Response Under 37 CFR §1.116
Expedited Procedure, Examining Group 3700
Application No. 10/089,247
Paper Dated: October 1, 2004
In Reply to USPTO Correspondence of June 2, 2004
Attorney Docket No. 1918-020512

AMENDMENTS TO THE DRAWINGS

FIG.2

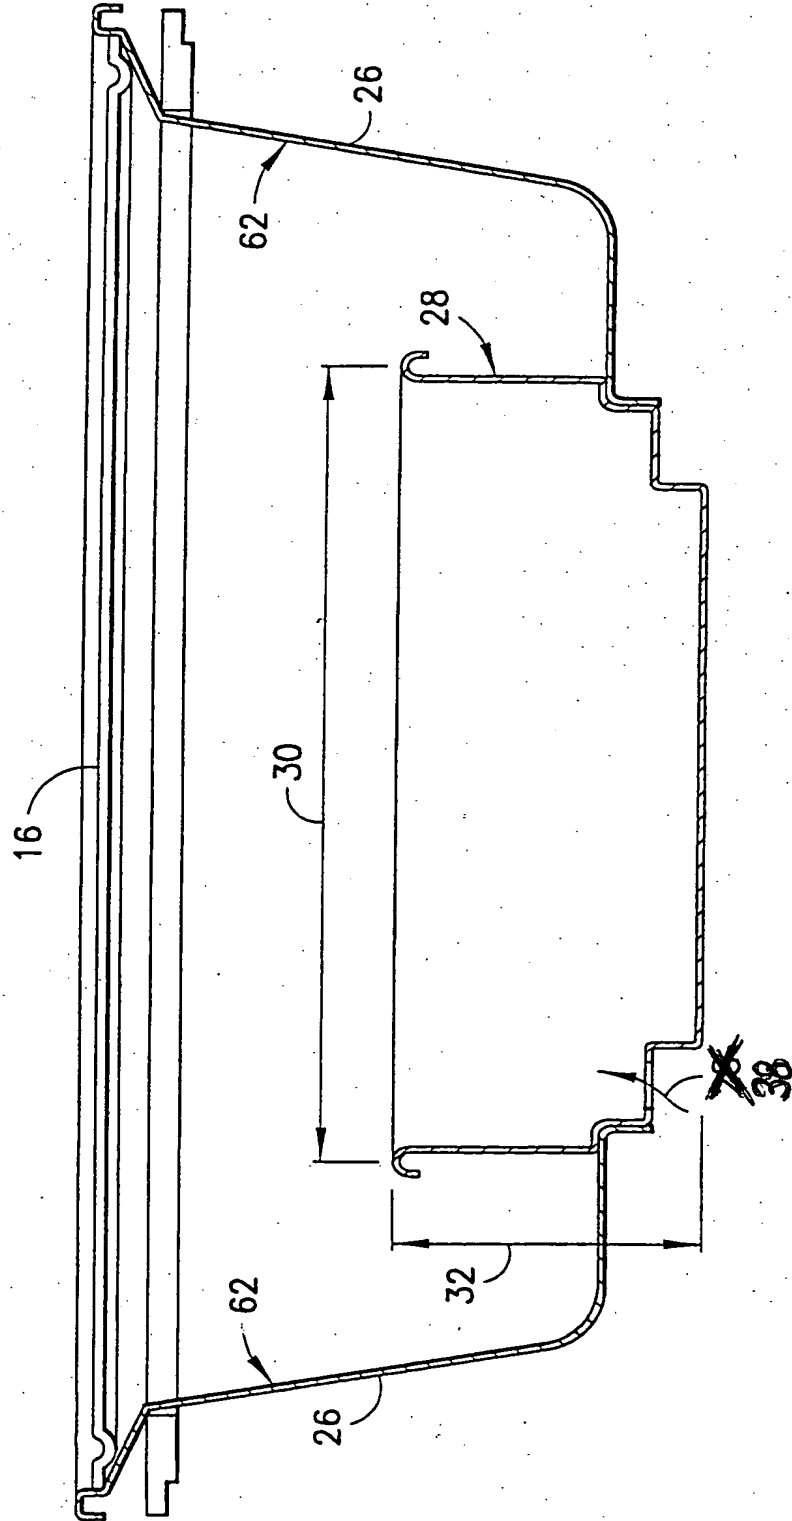
The drawings stand objected to because of certain informalities discussed on pages 3 and 4 of the Office Action. Applicant includes herewith proposed drawing changes to Figs. 1 and 2 for the Examiner's review and approval. In Fig. 1, reference numeral 57 has been changed to "56" and reference numeral 50 has been changed to numeral "57." In Fig. 2, reference numeral 28 has been changed to numeral "38." Upon acceptance of the proposed amended drawings, entry of the replacement drawing sheets of Figs. 1 and 2 are respectfully requested.

The attached replacement sheets of drawings include changes to Figures 1 and 2. The replacement sheets of drawings replace the original drawing sheets of Figures 1 and 2. Changes incorporated into the replacement sheets are highlighted in red on the attached annotated copies.
